# Economic and Social Council

**UN GTR No. 6 (Safety Glazing)**

### **Authorization to develop an amendment to UN Global Technical Regulation No. 6 (Safety Glazing)**

#### **Submitted by the representative from Republic of Korea\***

Figure 4  
**Determination of Zone 1**

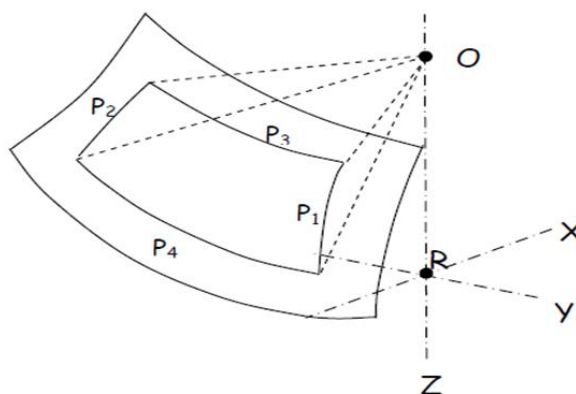
- (v) Para. 7.1.3.3.2. Zone I is the zone determined by the intersection of the windscreen with the four planes defined below:

In addition, opaque obscuration can be exempted in Zone I. It is the limited areas where it is intended that a sensing device, e.g. a rain-drop detector, rear view mirror or autonomous vehicle sensors, will be bonded to the inner side of the windscreen. The opaque obscuration where such devices may be applied is defined in paragraph 7.1.3.2.4.(Figure 2(a) or Figure 2(b)) of this annex.
